APPROVED DRAWINGS HAVE BEEN RED LINED INDICATING A CHANGE TO MEET THE OBC. PLEASE REVIEW ALL PAGES TO ENSURE YOU ARE PROPERLY INFORMED OF CHANGES.

Tice River Homes Legacy

client
Tice River Homes
project
Legacy

BASEMENT PLAN ELEV. 'A' & 'B'

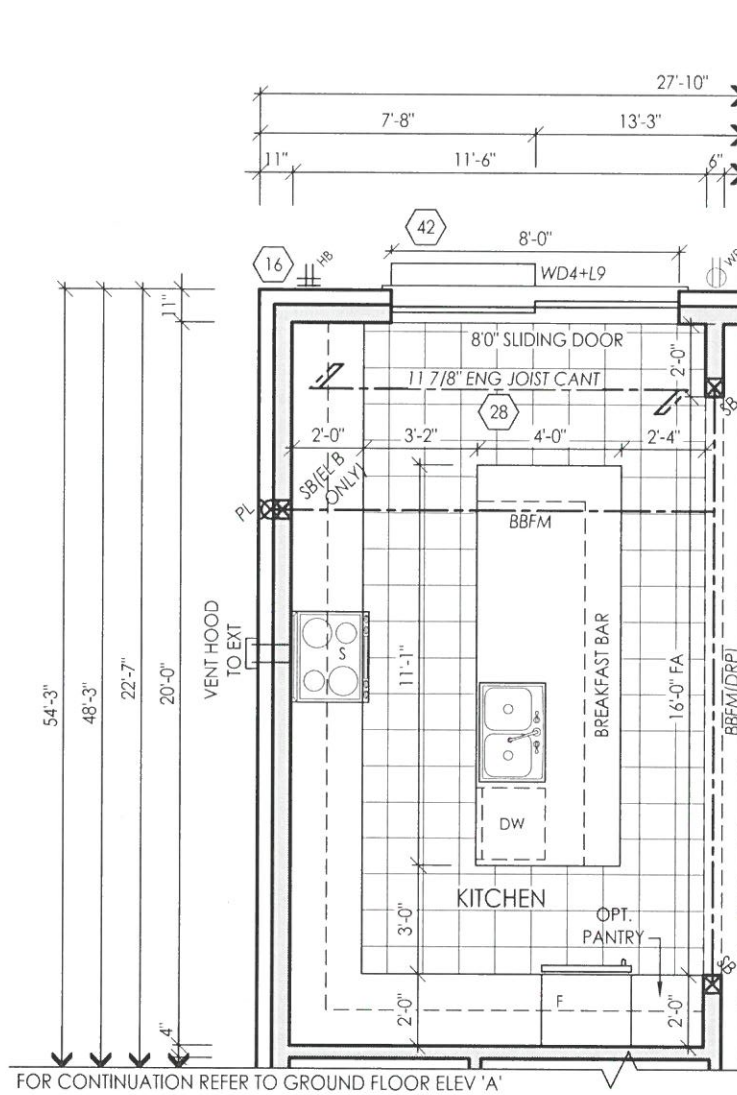
**BASEMENT AIR BARRIER
SUMP PUMP LIDS, JOINTS AT INTERSECTIONS & ALL
PENETRATIONS OF SLAB MUST BE SEALED TO
PREVENT AIR LEAKAGE.**

**MAX
PROJECTION AS
PER ZBL**

**SUMP PUMP/PIT SHALL BE INSTALLED
AND AND CONNECTED ACCORDING TO
LOCAL REGULATIONS.**

**THE COLD CELLAR DOOR
NEEDS TO BE INSULATED AND
WEATHERSTRIPPED**

**CONCRETE PORCH
SLAB
-MIN. 4 7/8" THICK SLAB
-10m BAR @ 8"O.C.
EACH WAY
-24"x24 10M BAR
DOWELS @ 24"O.C.
-MIN. 1 1/4" CONCRETE
COVER
-MIN. 32MPa CONCRETE
-MIN. 3" BEARING**

GROUND FLOOR ELEV. 'B'

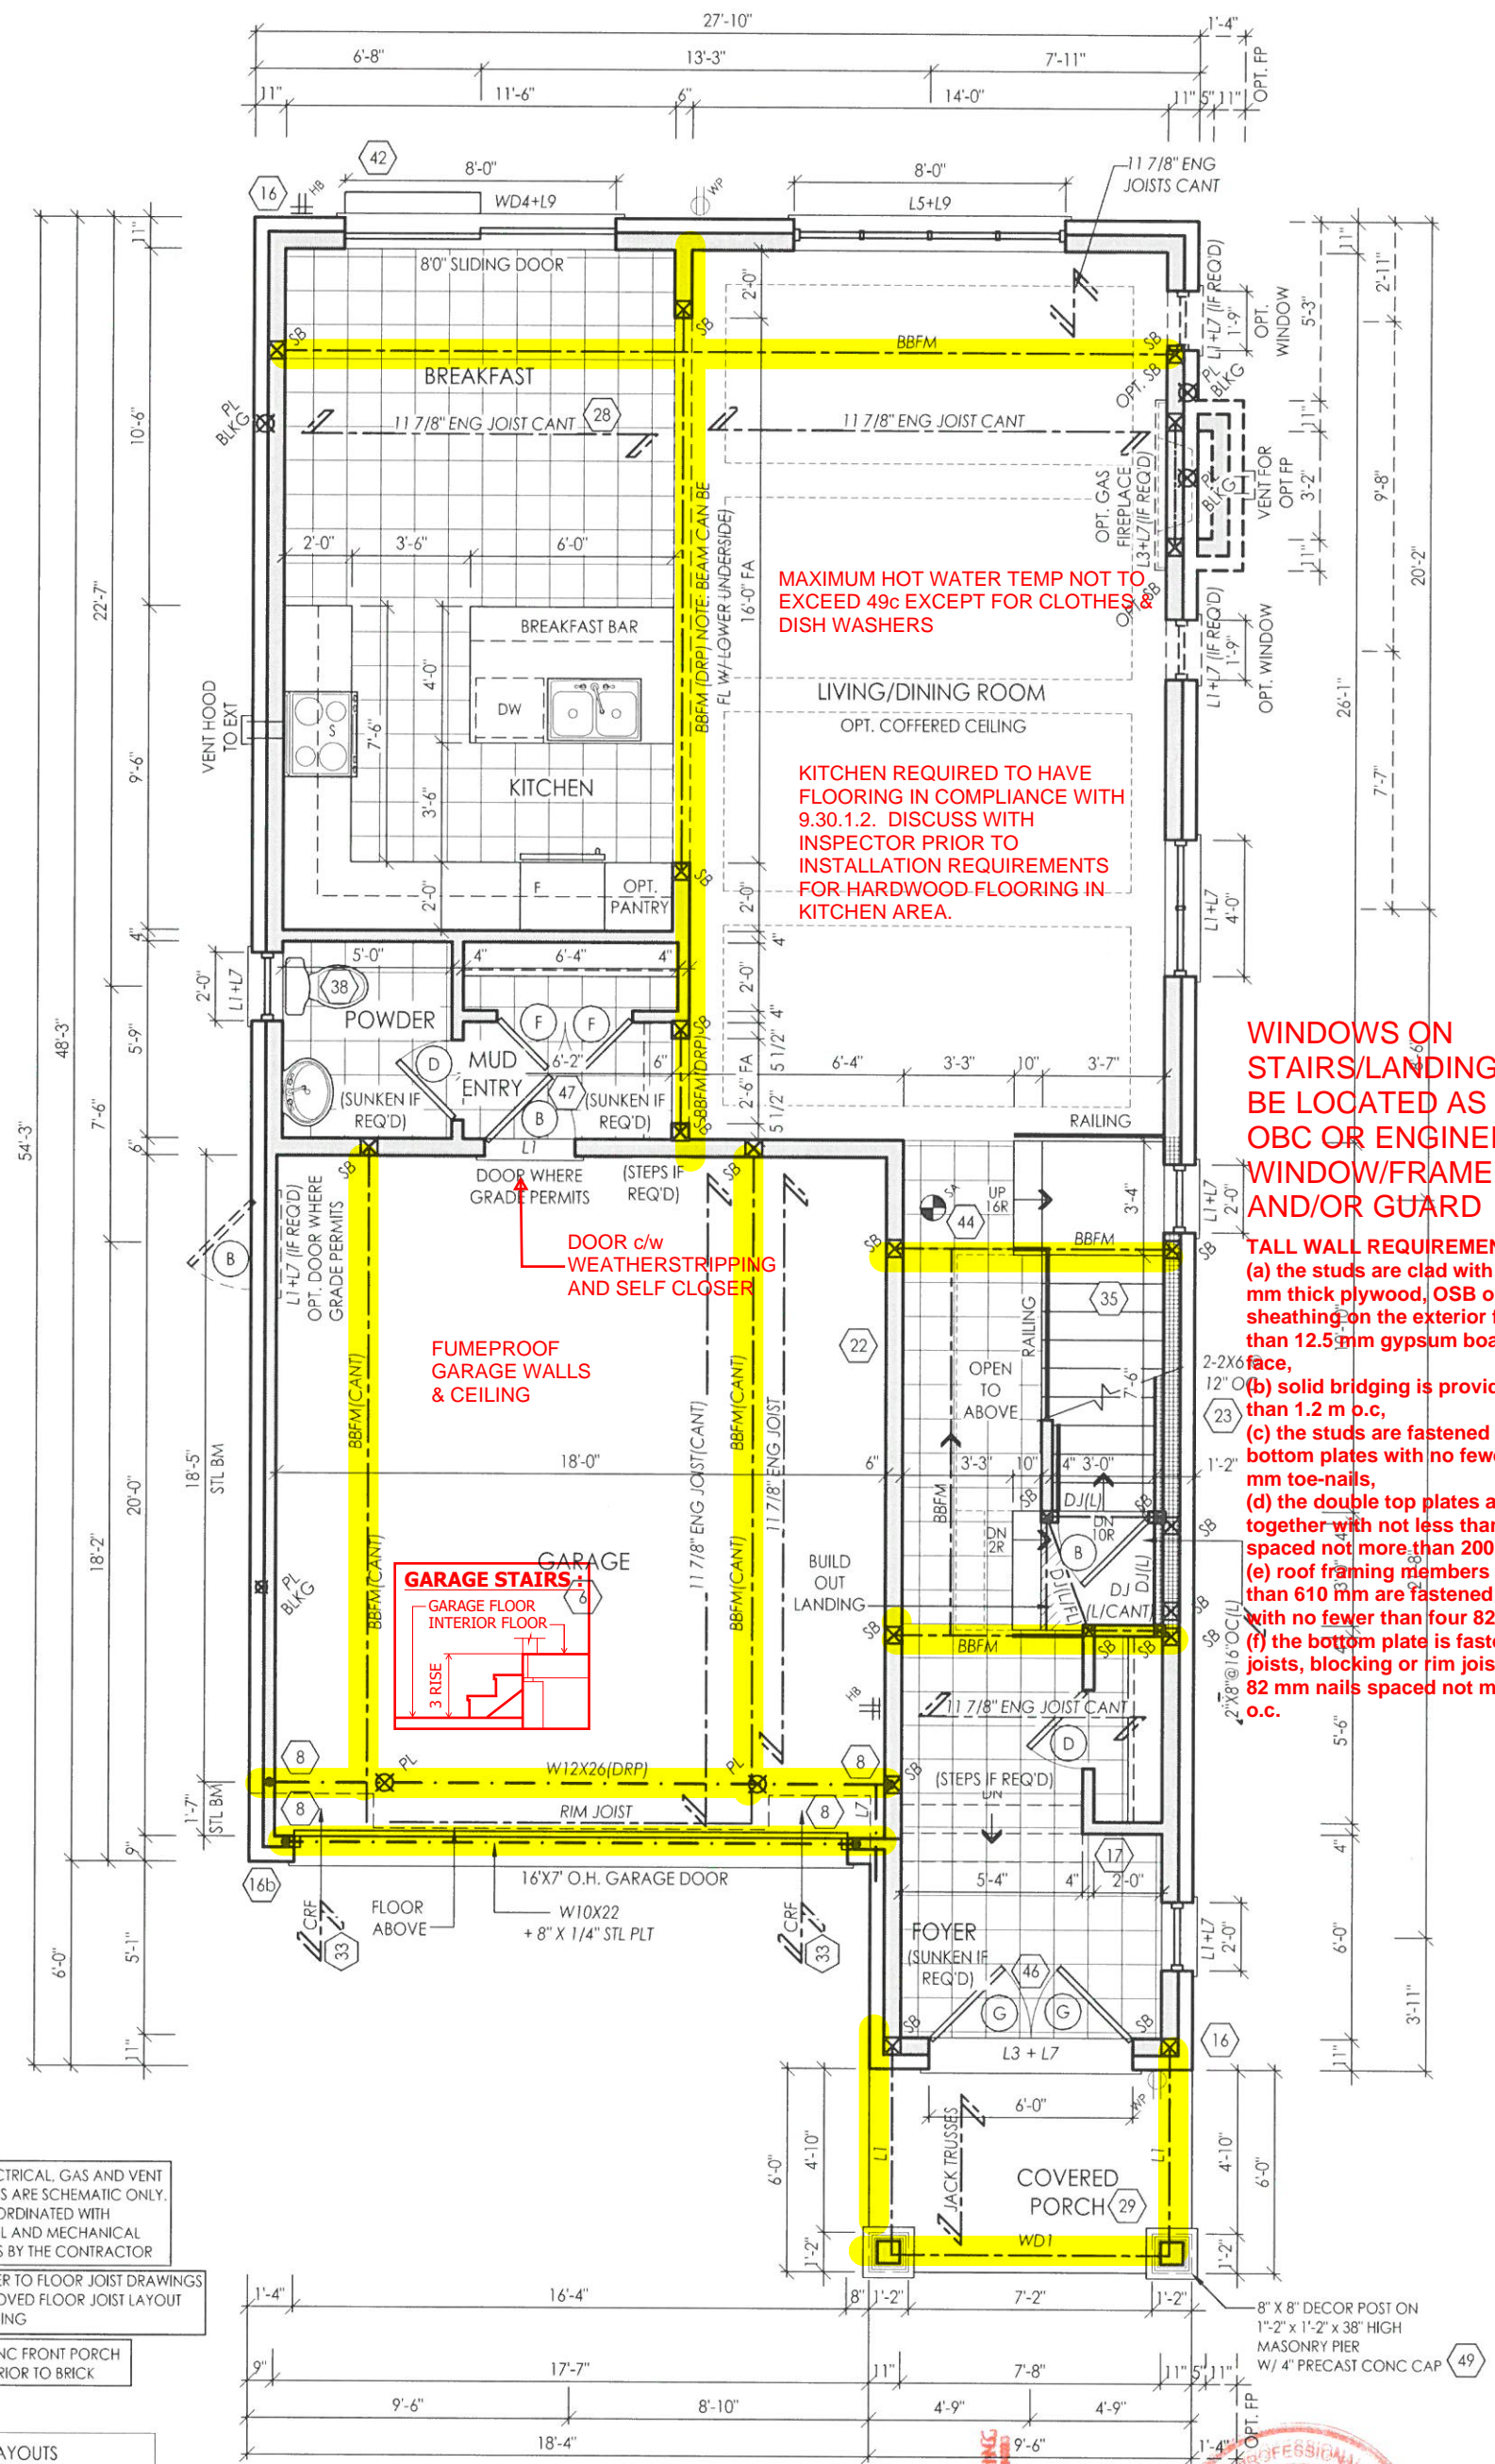
MAXIMUM HOT WATER TEMP NOT TO EXCEED 49c EXCEPT FOR CLOTHES DISH WASHERS

KITCHEN REQUIRED TO HAVE FLOORING IN COMPLIANCE WITH 9.30.1.2. DISCUSS WITH INSPECTOR PRIOR TO INSTALLATION REQUIREMENTS FOR HARDWOOD FLOORING IN KITCHEN AREA.

WINDOWS ON STAIRS/LANDINGS TO BE LOCATED AS PER OBC OR ENGINEERED WINDOW/FRAME AND/OR GUARD

TALL WALL REQUIREMENTS
 (a) the studs are clad with not less than 9.5 mm thick plywood, OSB or waferboard sheathing on the exterior face, and not less than 12.5mm gypsum board on the interior face,
 (b) solid bridging is provided at not more than 1.2 m o.c.,
 (c) the studs are fastened to the top and bottom plates with no fewer than three 82 mm toe-nails,
 (d) the double top plates are fastened together with not less than 76 mm nails spaced not more than 200 mm o.c.,
 (e) roof framing members spaced not more than 610 mm are fastened to the top plates with no fewer than four 82 mm toe-nails, and
 (f) the bottom plate is fastened to the floor joists, blocking or rim joist with not less than 82 mm nails spaced not more than 200 mm o.c.

NOTE: CONC FRONT PORCH POURED PRIOR TO BRICK

page: _____
A5

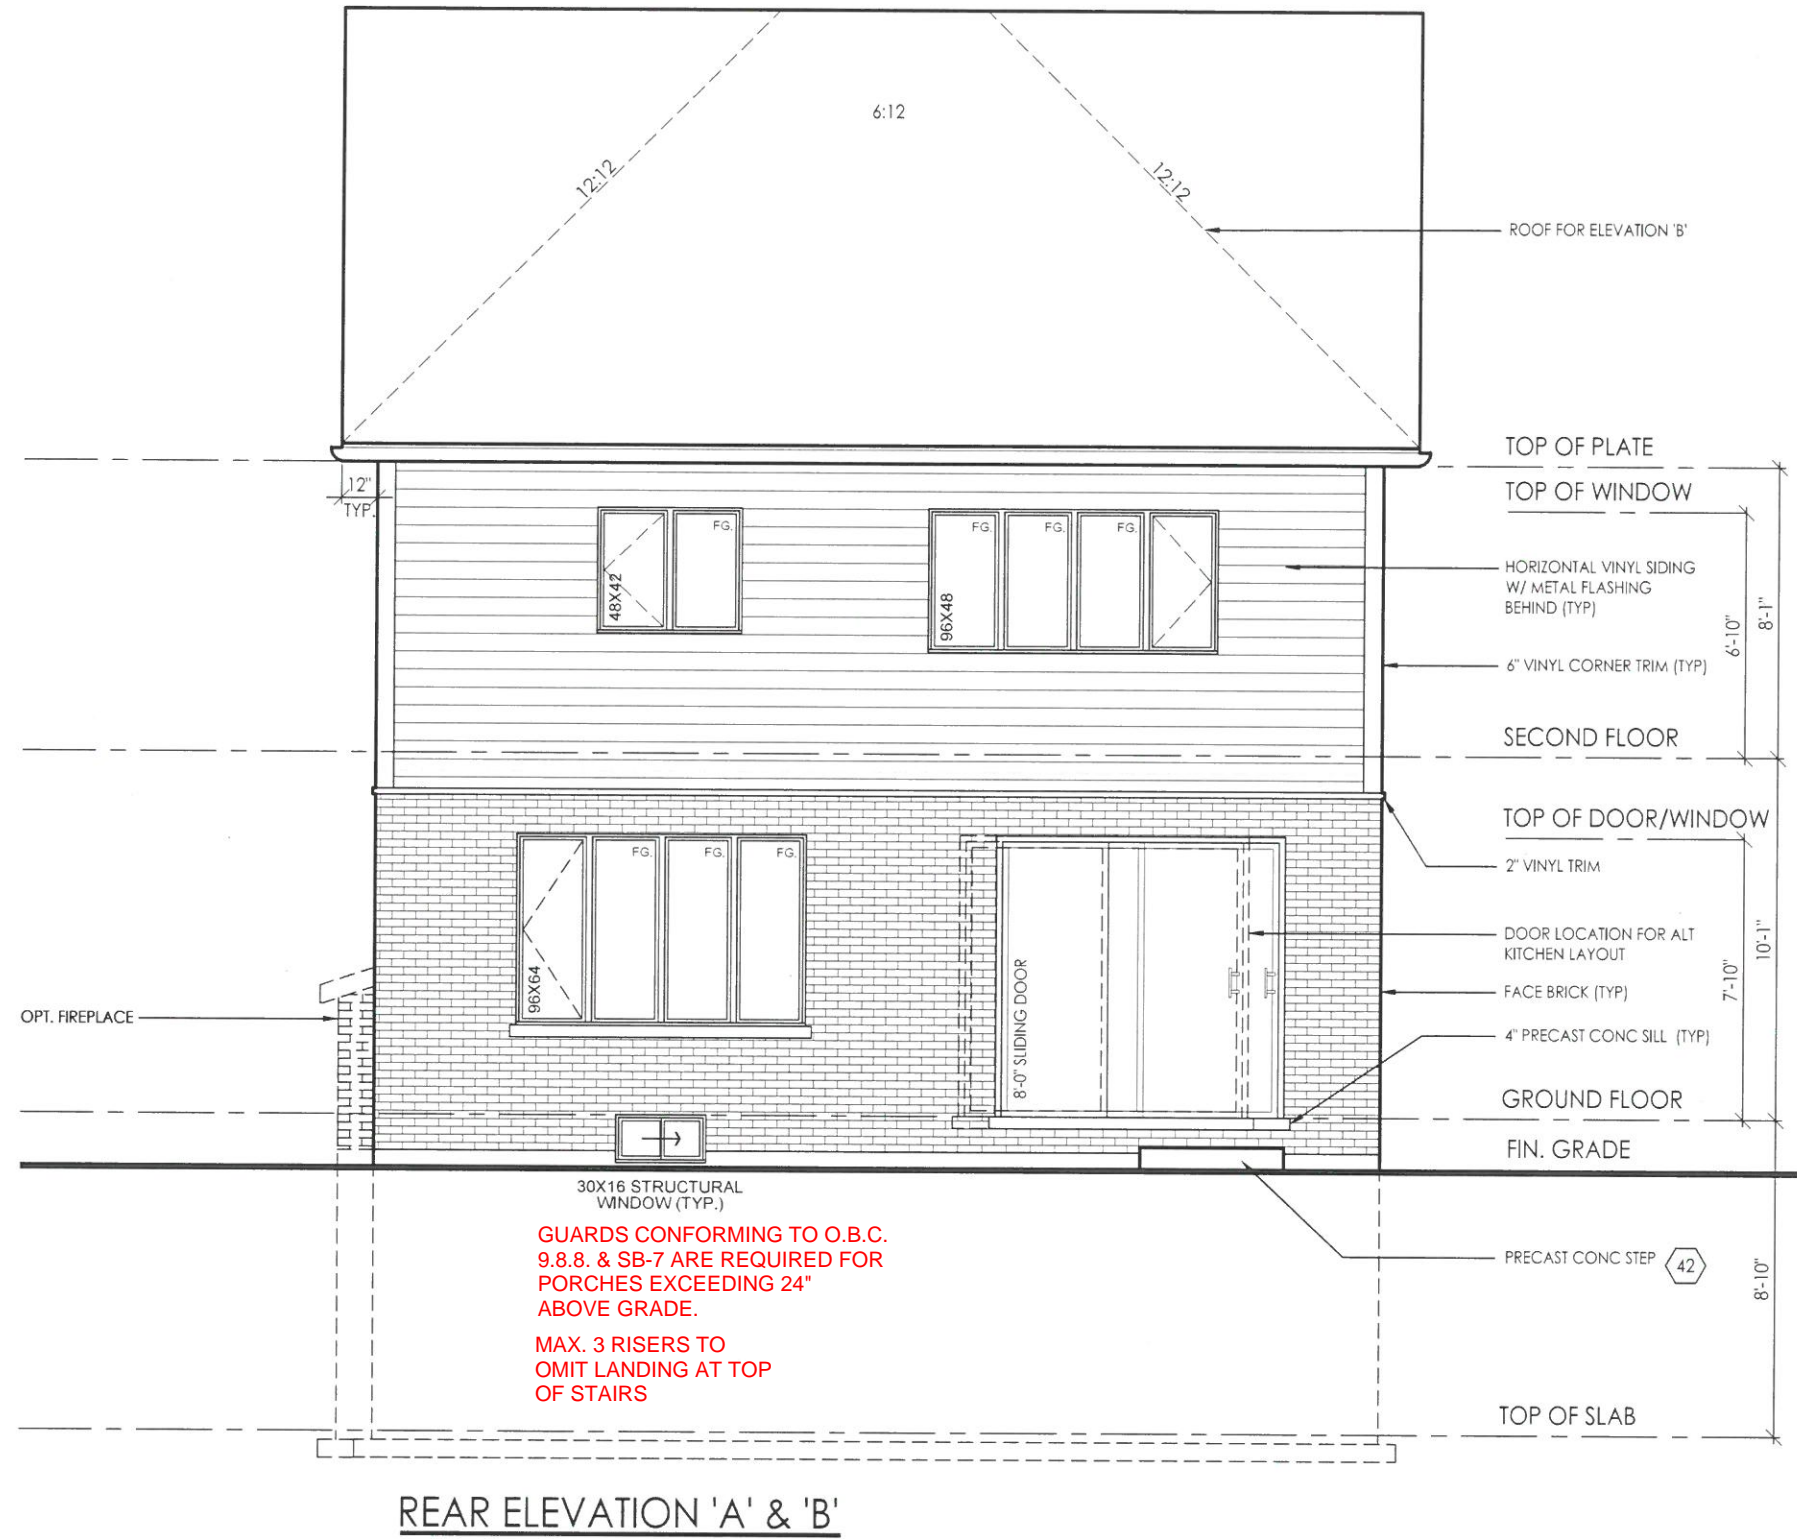
GUARDS CONFORMING TO O.B.C. 9.8.8. & SB-7 ARE REQUIRED FOR PORCHES EXCEEDING 24" ABOVE GRADE.
 MAX. 3 RISERS TO OMIT LANDING AT TOP OF STAIRS

FRONT ELEVATION 'B'

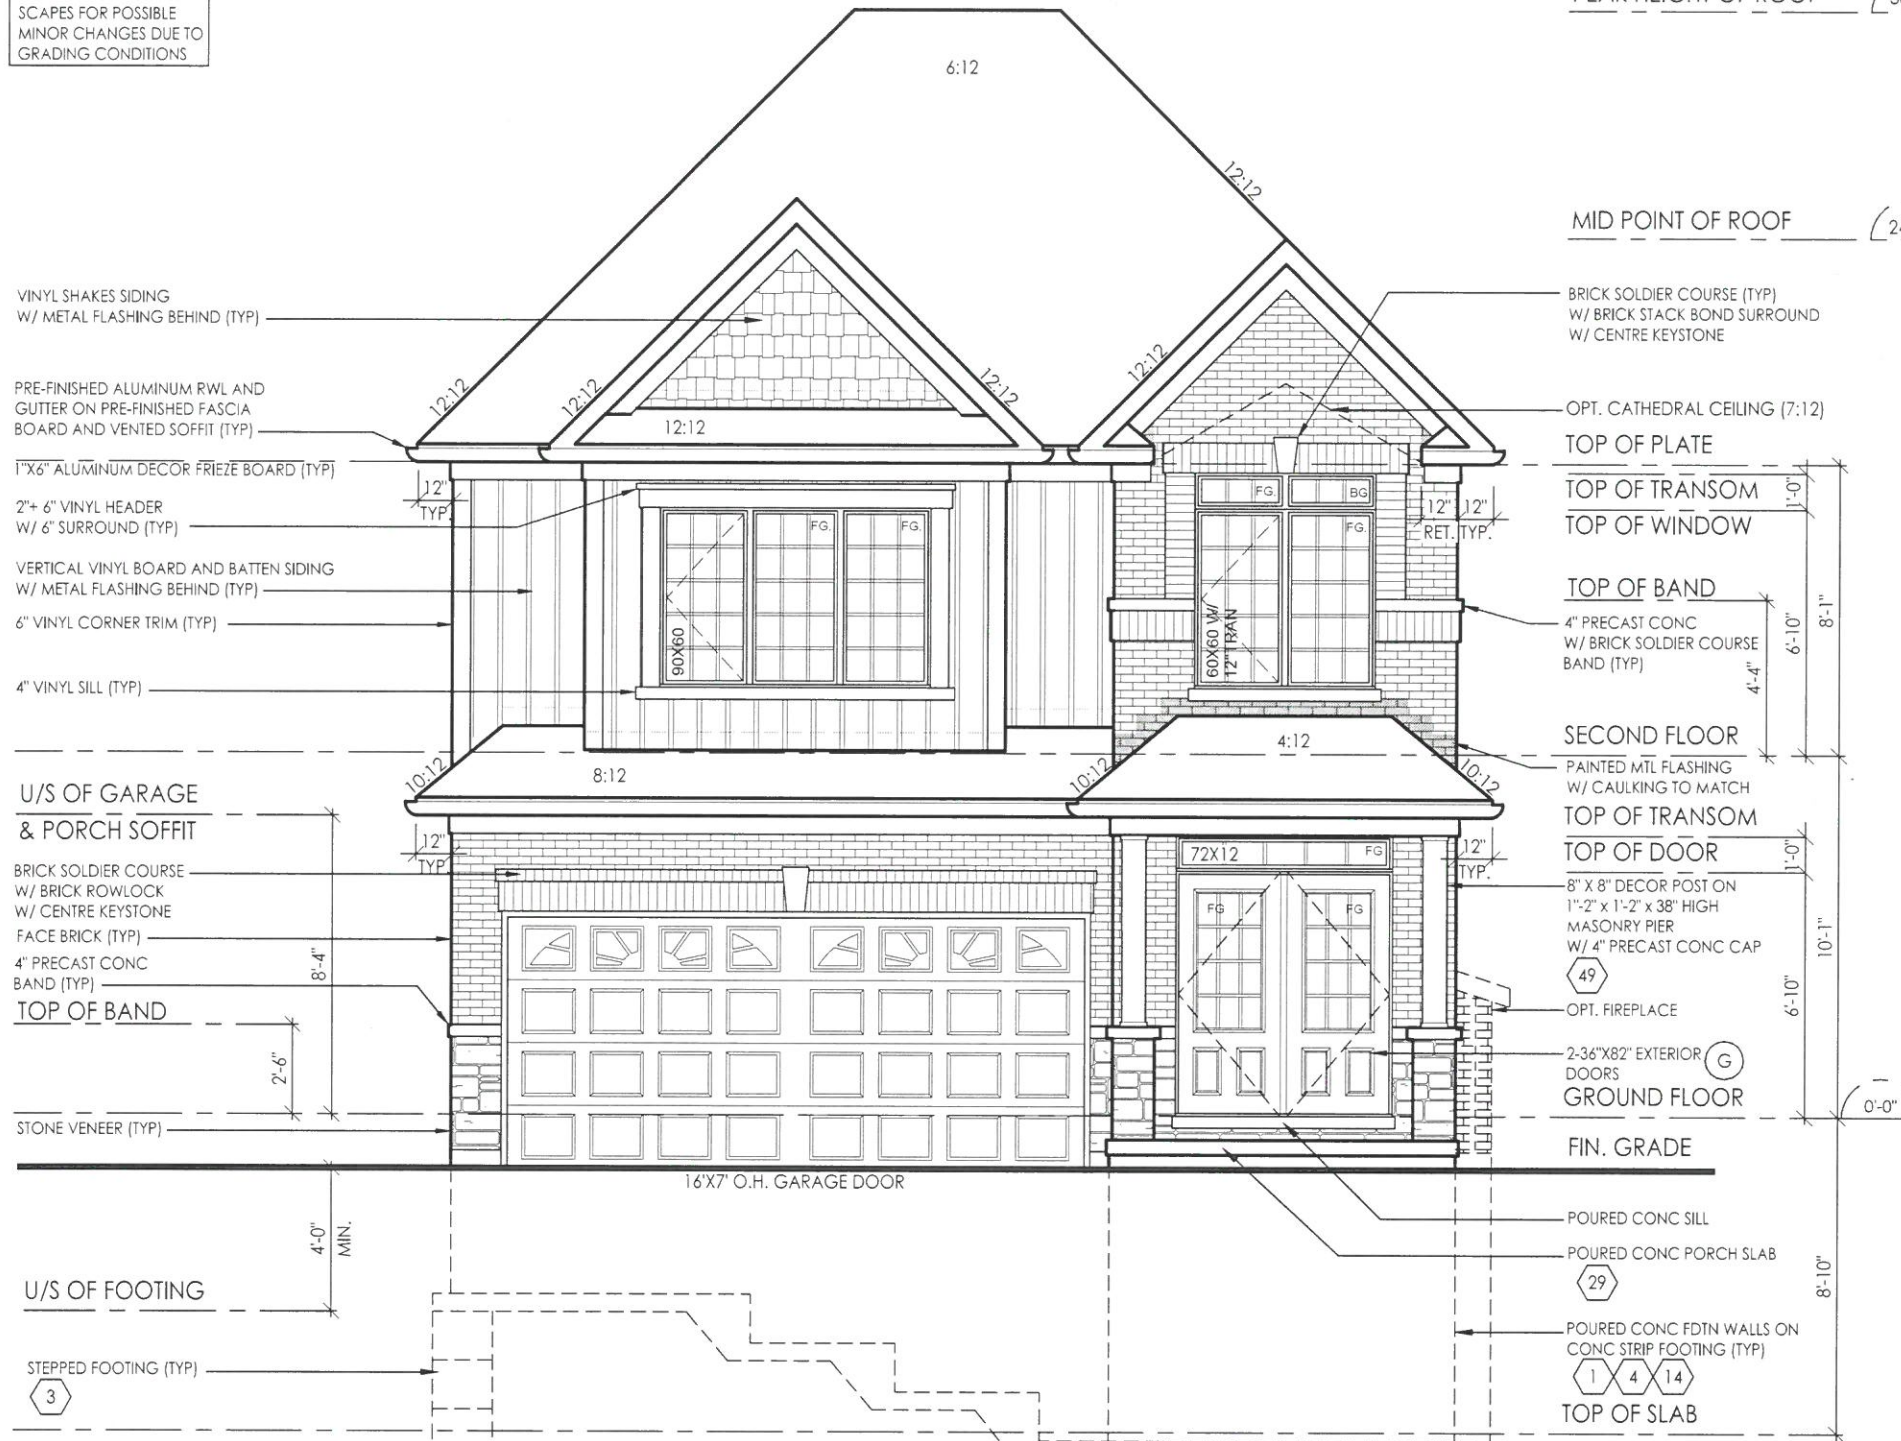
THE FINAL GRADING OF THIS PROPERTY SHALL NOT ADVERSLY EFFECT THE DRAINAGE OF ADJACENT PROPERTIES OR THE OVERALL GRADING CONTROL PLAN.
